Docket Number:	01-EP-10C
Project Title:	Enterprise Emergency Peaker Project - Compliance
TN #:	268224
Document Title:	CEC_Data Response_Enterprise Worker Safety and Fire Protection_Supplemental Information
Description:	Response to Data Request for Enterprise Emergency Peaker Project, Docketed Date 11/4/2025.
Filer:	Grace Myers
Organization:	Rincon Consultants, Inc.
Submitter Role:	Applicant Consultant
Submission Date:	1/12/2026 2:21:02 PM
Docketed Date:	1/12/2026

Enterprise Emergency Peaker (01-EP-10C) Enterprise BESS Project

CEC Hazardous Materials Management/Worker Safety
and Fire Protection Data Request
Response No. 2, Supplemental Information for
DR-18, -20, -21, and -22

Water System
#74 2361 Auto Park Way - Fire Flow Analysis

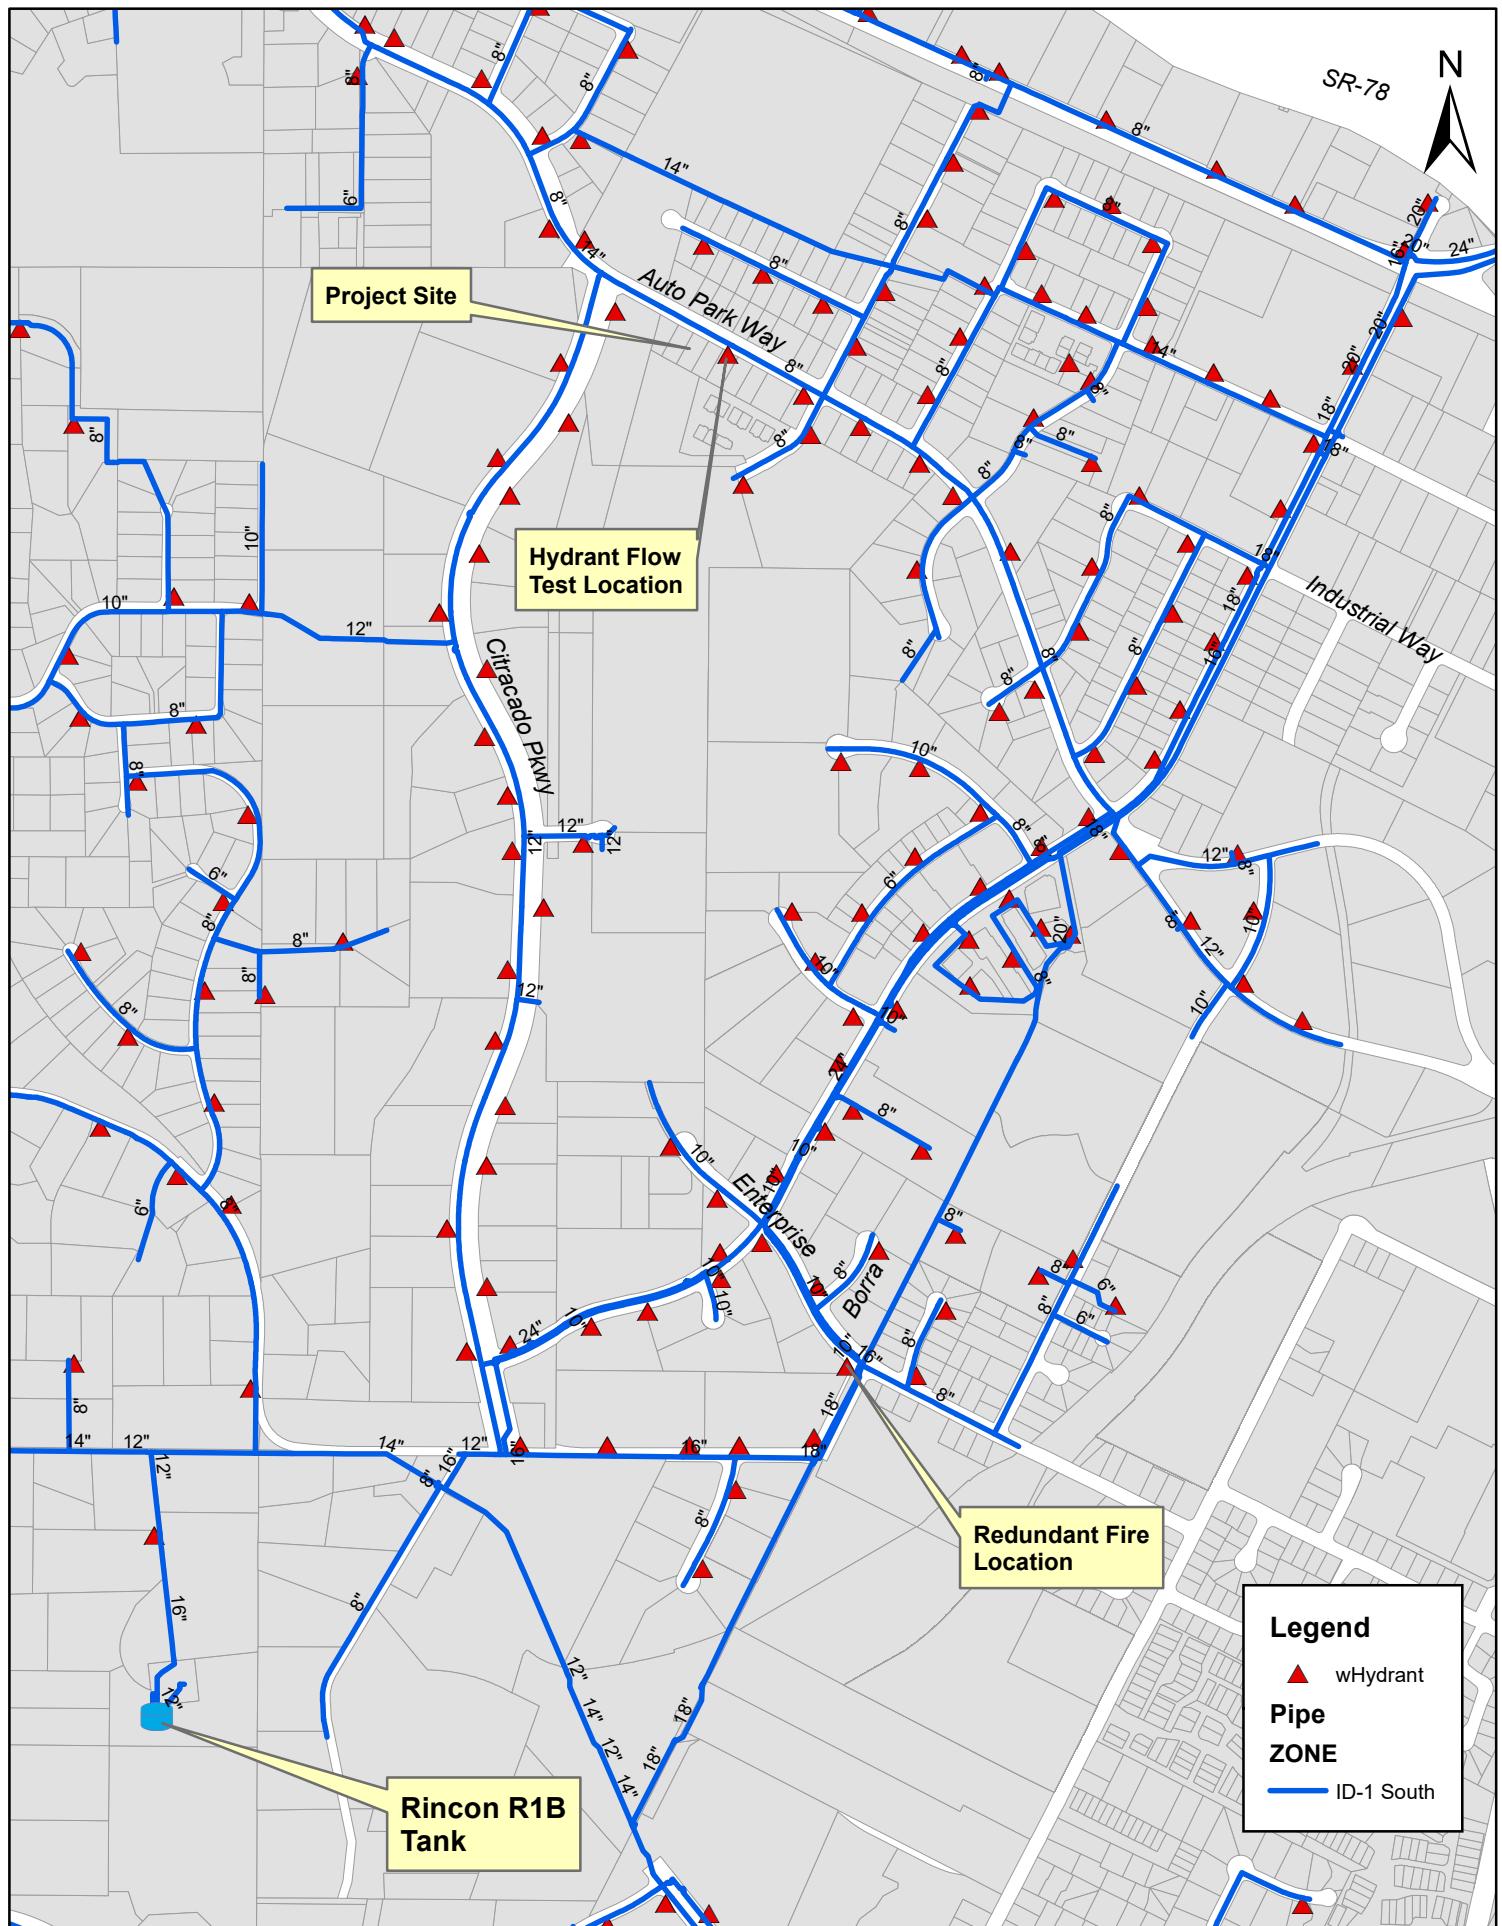
Location of test (reference map required): Auto Park Way east of Citracado Pkwy

Flow Test Results		
Static pressure:	<u>111</u> PSI	Hydrant Number (if applicable): <u>429</u>
Elevation of test:	<u>702</u> Feet	Main Diameter: <u>8</u> INCH
Service Area:	<u>ID-1 South (958' HGL)</u> Feet	
Total Flow:	<u>2,000</u> GPM	Residual Pressure <u>69</u> PSI

The District requires a dual fire in the vicinity of the original fire, except in the Escondido Research and Technology Center (ERTC) area along Citracado Parkway. For this Project, a dual fire was placed along an existing 10-inch main in Enterprise Drive east of Borra.

At peak demand, this water system is capable of providing a fire flow discharge @ 20 psi in the vicinity of the fire of 2,750 gpm onsite and 2,750 at the dual fire location, for a total of 5,500 gpm. The requested fire flow of 2,000 gpm with the redundant fire results in a residual pressure of 69 psi at the project location.
